From: [REDACTED]
To: [REDACTED]
CC: [REDACTED]
Sent: 2/24/2021 5:29:11 PM
Subject: RE: O8W-PM 35217268, 35224712, 35224713 - Bucks Creek 1101 Phase 1,2&3 - Pre-Engineering Meeting
Importance: High

Subject: O8W-PM 35217268, 35224712, 35224713 - Bucks Creek 1101 Phase 1,2&3 - Pre-Engineering Meeting

PM 35217268 (Phase 1)

Bucks Creek 1101- PM# 35217268 Overview Map

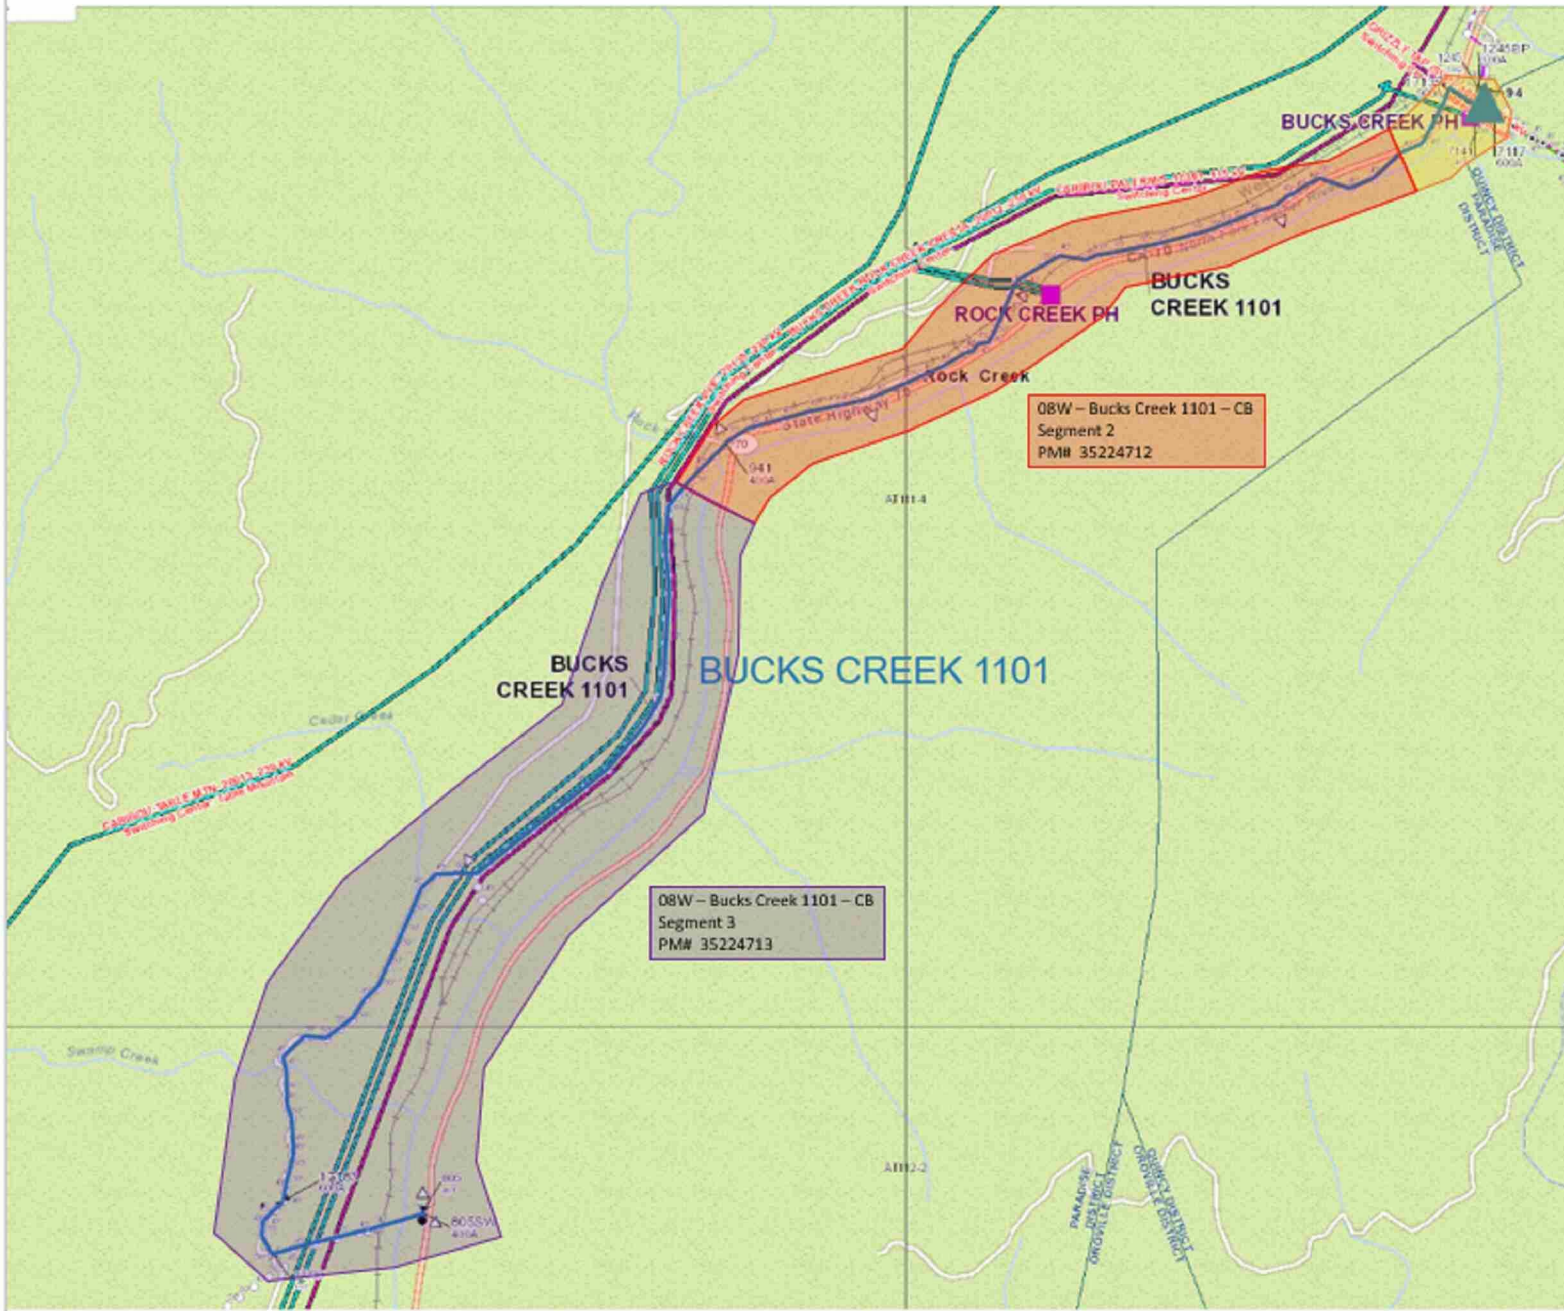
For Bucks Creek there is quite a bit of work surrounding Hwy 70 and we will need a Land Department

Base Maps prepared for all 3 Orders. This will delay the EOD dates until these can be developed and provided to the Vendor... We will also need answers to the questions outlined by [REDACTED] below...
